1st September 1885, No. 986, Revenue.

Taluk Cutcherry (2nd Class) at Manantoddy.

Plan Se on and Elevation
of the
Taluq Cutcherry at Manantoddy

Taluq Cutchery at Manantoddy

Section thro' E.F.

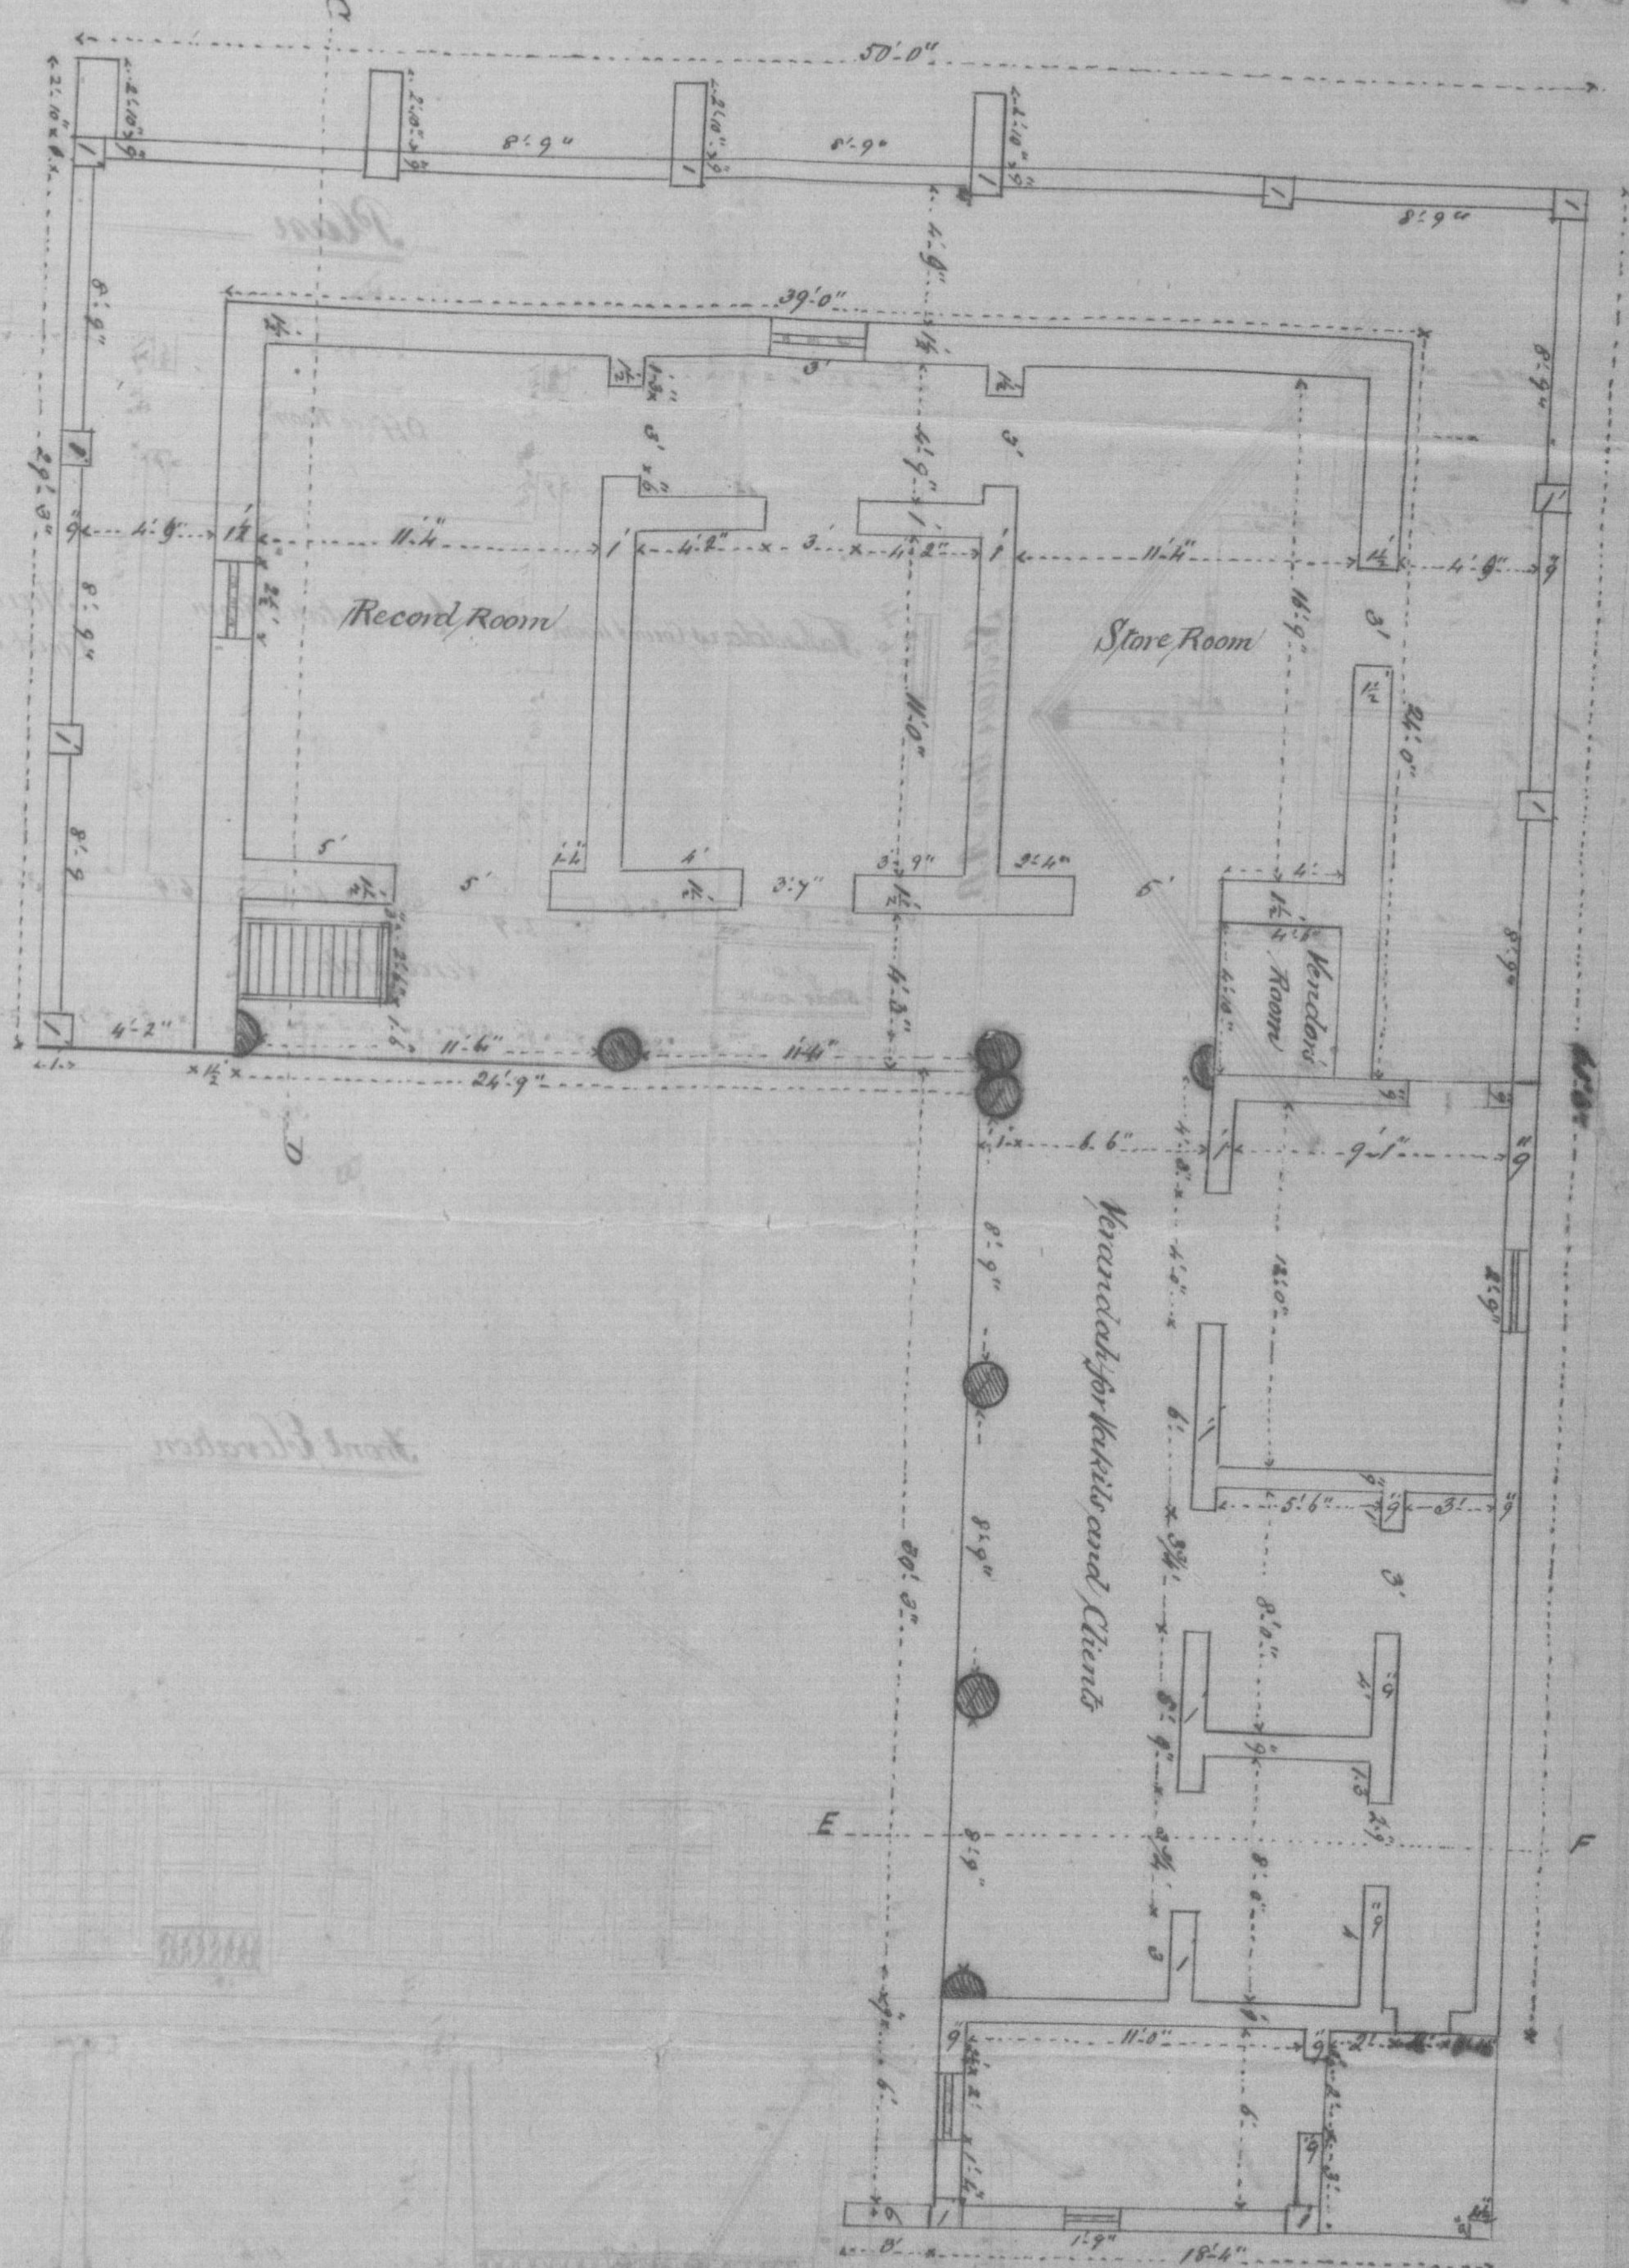
(4) The rooms are so low and ill-ventilated as to be sometimes almost stifling. Owing to the small size of the doors, even ordinary almirahs cannot be taken into them. The lighting is so bad that the clerks have to use lamps on cloudy days. Also owing to weakness of construction the whole building shakes in any strong wind;

(5) The treasury being in a detached building with no covered way between it and the main building, the Tahsildar and his establishment are subject to great inconvenience in rainy weather in passing to and fro between it and the main building;

(6) The treasury, sub-jail, and police station are very insecure, in a dilapidated shaky condition, and infested with rats and snakes. The walls are so weak that prisoners have escaped by breaking holes in them, and a mad prisoner kicked down one of them. The arrangement of the rooms is so bad that efficient guarding is impossible, and the treasury room is so dark that a lighted torch is required when entering it even on a bright summer's day.

(7) Finally, the buildings are stated to be in such a tottering condition that they will probably collapse, either entirely or in part, during the present monsoon.

3. From personal inspection I can certify that the Tahsildar has not in any way misrepresented the state of the building, and it will, I think, be manifest that it would be waste of money attempting to repair and improve it.

4. I request permission to submit plans and estimates for a new second-class cutcherry.
